ACCELERATED DISTRIBUTION DEMONSTRATION SYSTEM

SUBJECT: Responds to 880518 & 0622 request for addl info re anticipated transients w/o scram.

Re: St. Lucie Plant Unit Nos. 1 and 2
Docket Nos. 50-335 and 50-389
Request for Additional Information
Anticipated Transients Without Scram

FLORIDA POWER & LIGHT COMPANY
ST LUCIE PLANT - UNITS 1 & 2
ATWS: RESPONSES TO NRC QUESTIONS
OF MAY 18 and JUNE 22, 1988

FIGURE 1

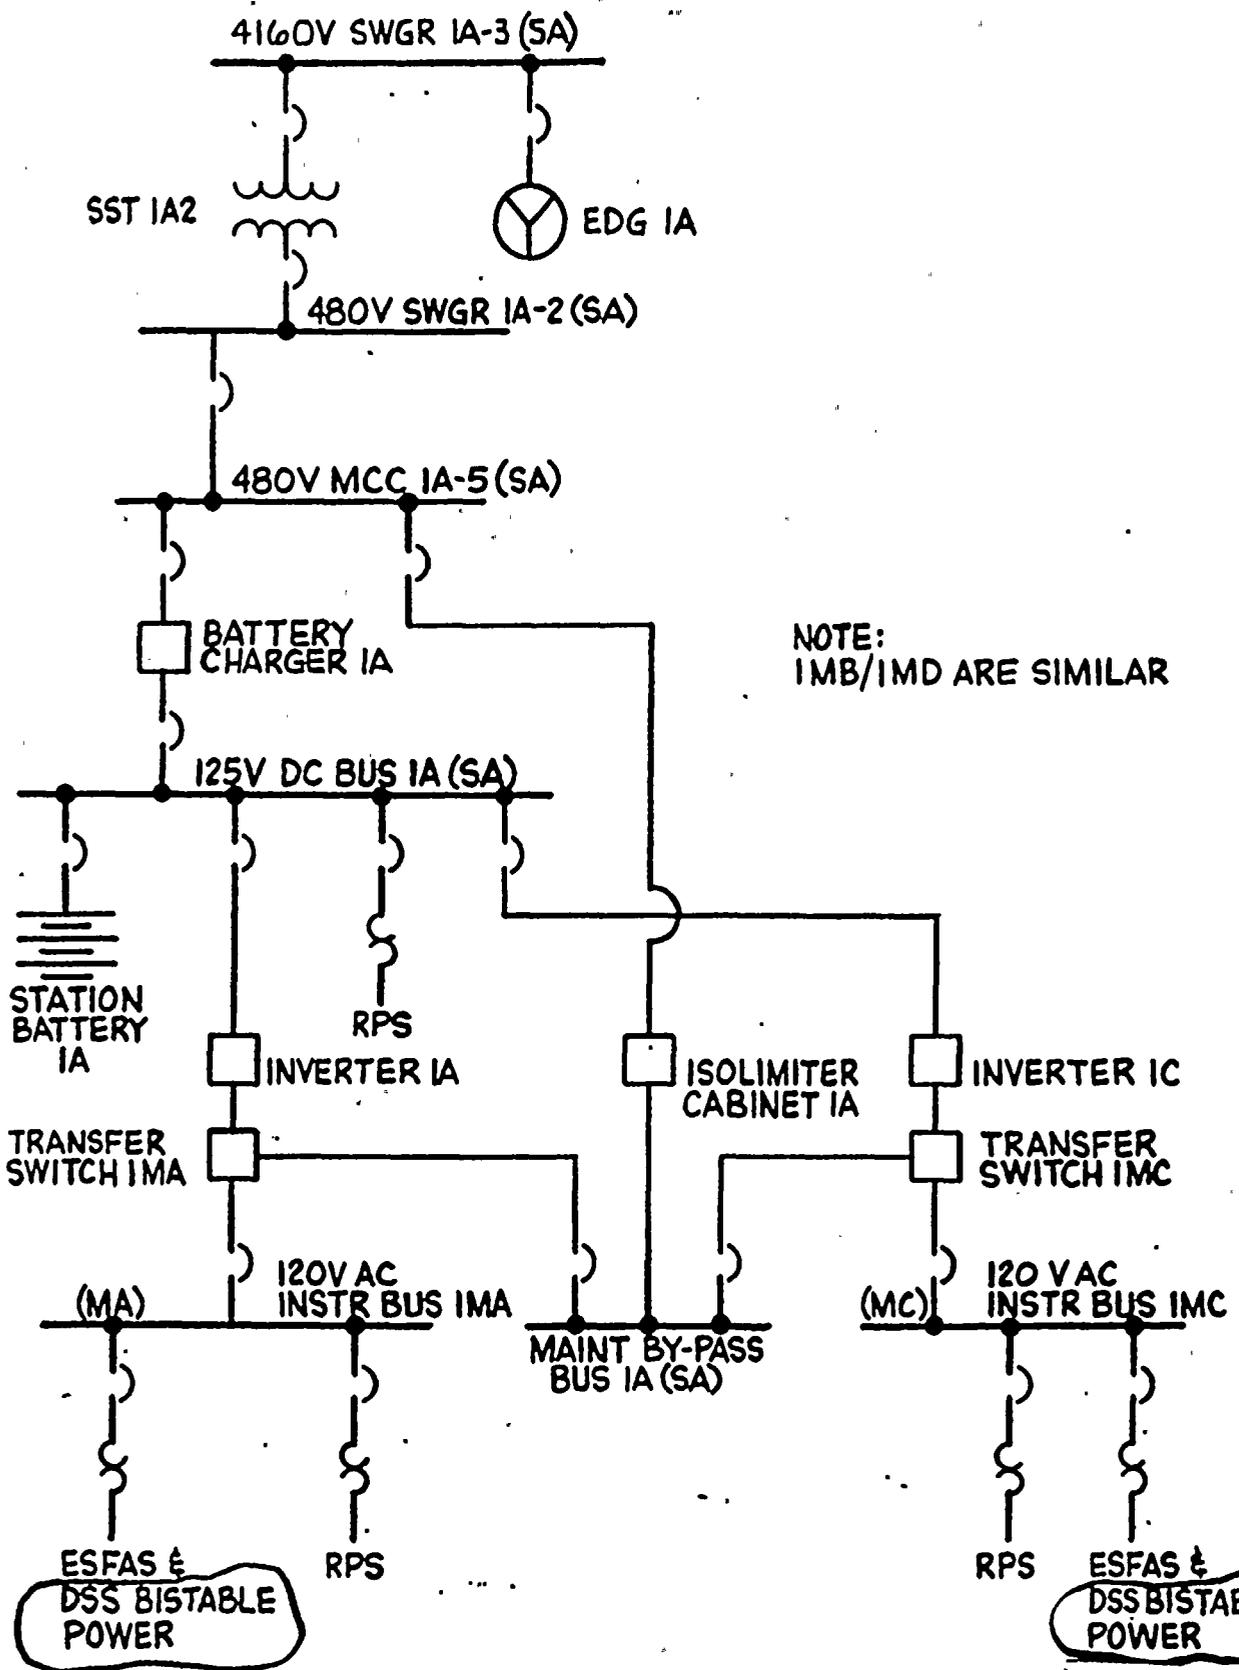
- a) Is the staff's understanding correct. If not, please explain.
- b) Part 1: Please provide electrical schematic/elementary diagrams for the DSS that clearly show all instrument channels (including bistables), logic, actuation circuits, test circuits, interlocks, bypasses, alarms and indications.

Part 2: Also, provide electrical one-line diagrams showing the CEA drive MG sets and DSS actuated output breakers, and power distribution to the RPS and ESFAS/DSS, including vital buses, inverters, batteries and chargers.

Figures 1, 2, 3, and 4 include electrical one-line diagrams for the RPS and ESFAS/DSS, including vital buses, inverters, batteries, and chargers. Figures 5 and 6 include electrical one-line diagrams for the CEA drive MG sets.

The one-line diagrams provided in response to question 1 identify the power sources for the RPS and DSS logic (Figures 1 through 4). As shown in the diagrams, power for the DSS logic in both units will be through isolation devices from vital, non-Class 1E 120Vac buses, which are different buses than the Class 1E buses feeding the RPS. The normal distribution path for DSS power will be through an uninterruptible power supply connected to both safety (SAB) and non-safety buses (Figures 2 and 4). If there is a failure at the 480 Vac or 4160 Vac levels, the non-Class 1E station battery (1D or 2D) will provide temporary power to the DSS logic while the Class 1E station batteries provide temporary power to the RPS and ESFAS loads. The emergency diesel generators will provide long-term backup power through the safety AB buses to the DSS logic.

FIGURE 7

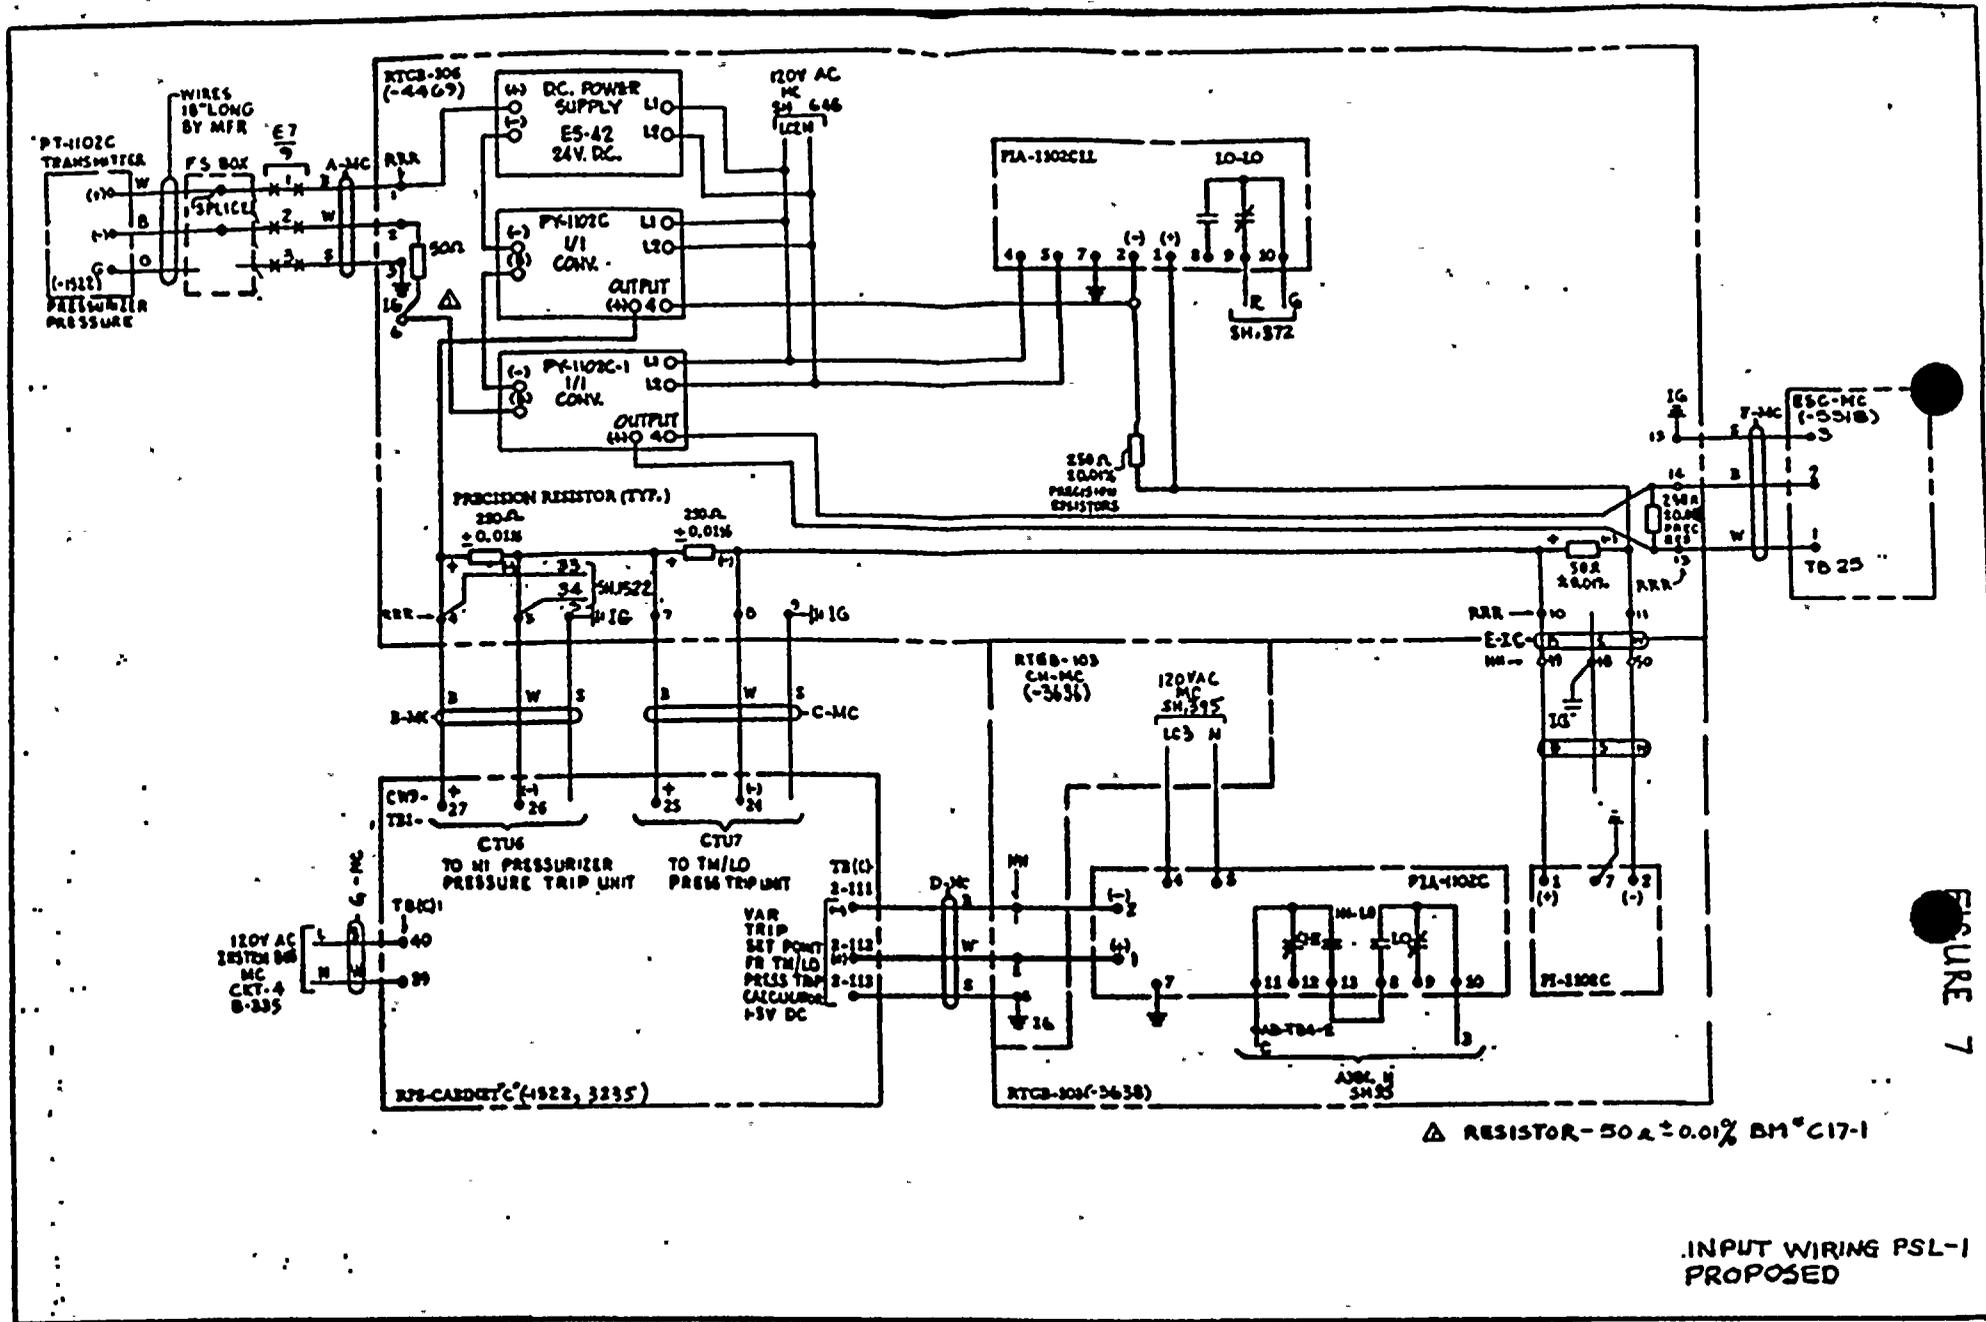
- a) Information must be provided to demonstrate the adequacy of all isolation devices used to protect the integrity of safety related circuits from non-safety related ATWS circuits. The required information is identified in Attachment 1*. If the isolation devices are identical to isolation devices used in other applications (e.g., to isolate the safety parameter display system from safety related circuits), and the requested information has been previously submitted for staff review, and the isolation devices have been approved for their applications, the related correspondence should be referenced, and no additional information need be provided.

Devices used to isolate the ESFAS/DSS circuitry from the safety related RPS are not yet installed in St Lucie - Unit 1. As can be seen in Figure 7, a single I/I (current to current) converter provides pressurizer pressure signals to the Sequence of Events cabinet, ESFAS cabinet MC, a pressure indicator in RTGB-103, and the RPS circuitry in RPS cabinet C. A second similar I/I converter will be installed in RTGB-106 which will supply pressurizer pressure signals to ESFAS and the DSS circuitry. This is similar for the other three pressure loops.

FIGURE 9

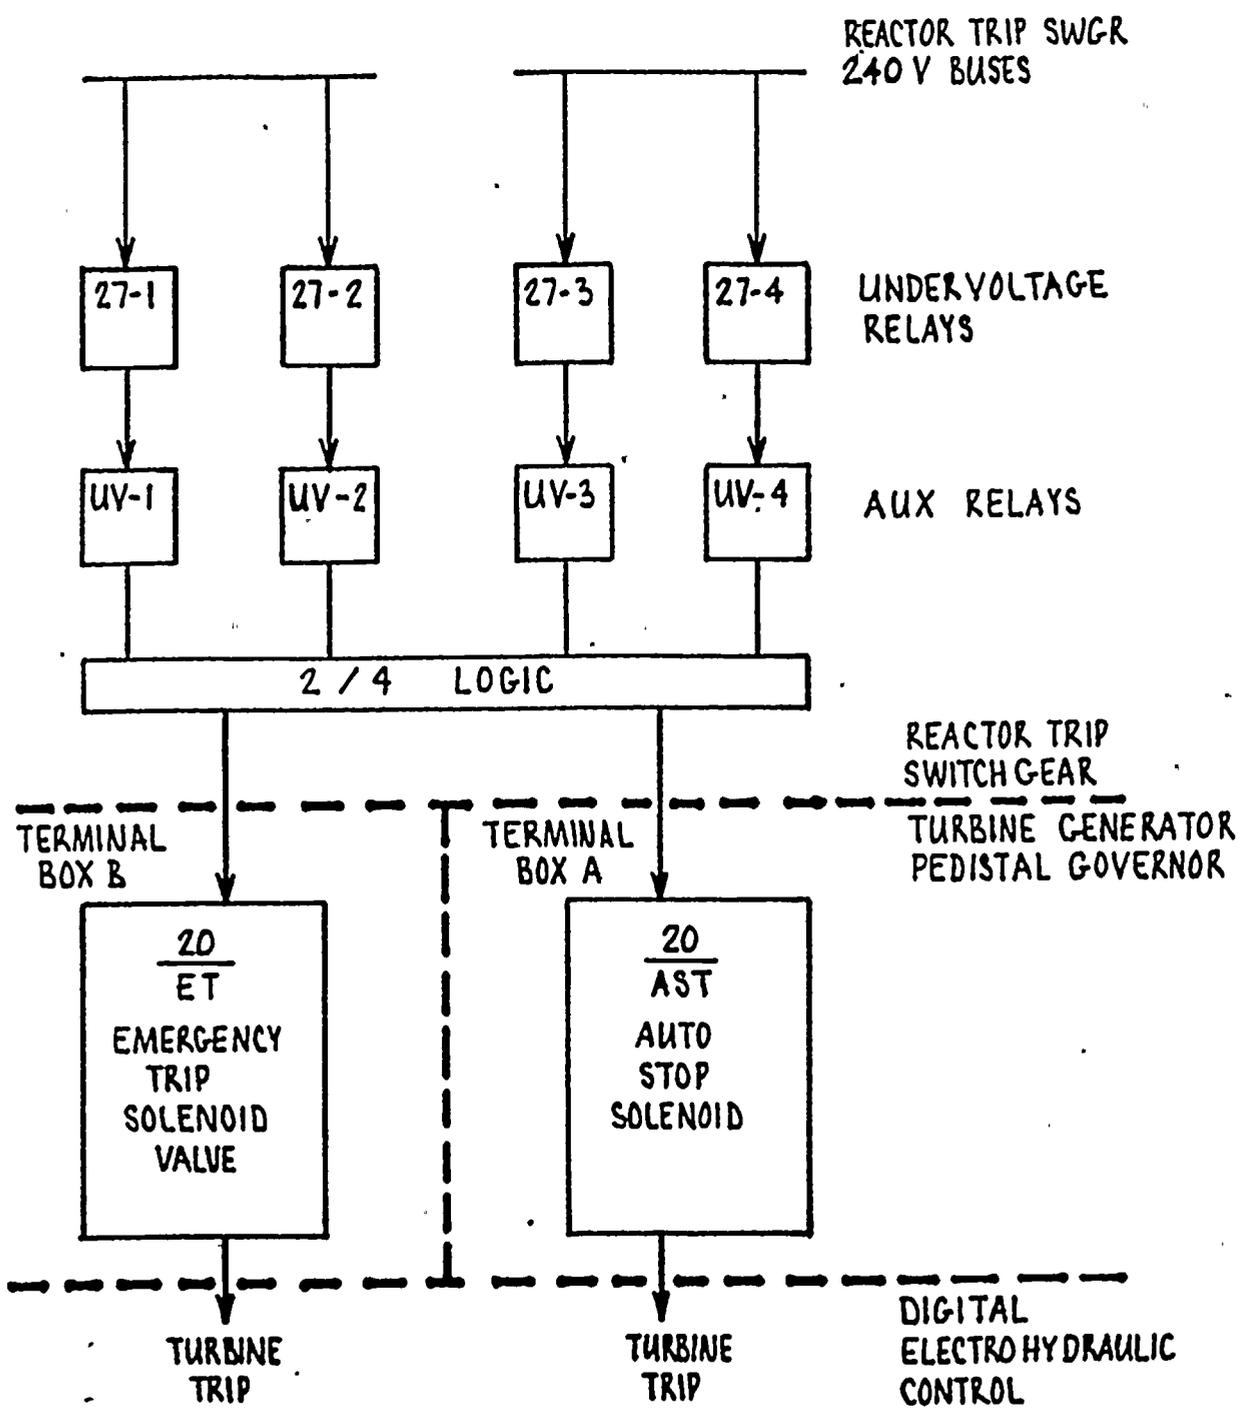
FPL's July 15, 1987 letter states that inherent to the DSS design is a turbine trip independent and diverse from the RPS, which is initiated by undervoltage conditions sensed in the CEA drive control system. Explain in detail how this arrangement satisfies the ATWS rule requirements for a diverse turbine trip. Please provide electrical schematic/elementary diagrams of the DTT circuits.

The existing turbine trip is diverse from the RPS in that the actuation of the turbine trip is based on an undervoltage condition in the reactor trip switchgear and is not based on the RPS logic. This assumes that there is an operational DSS which causes the undervoltage condition regardless of the status of the reactor trip breakers. As can be seen in the one-line diagrams in Figures 9 and 10, there are four voltage sensing devices (different devices for each Unit) that are fed into two 2/4 logic circuits, which in turn actuate to the auto trip solenoid and emergency trip solenoid valve to release auto stop hydraulic oil and emergency trip hydraulic oil, respectively. Loss of hydraulic oil pressure from either source will cause a turbine trip.
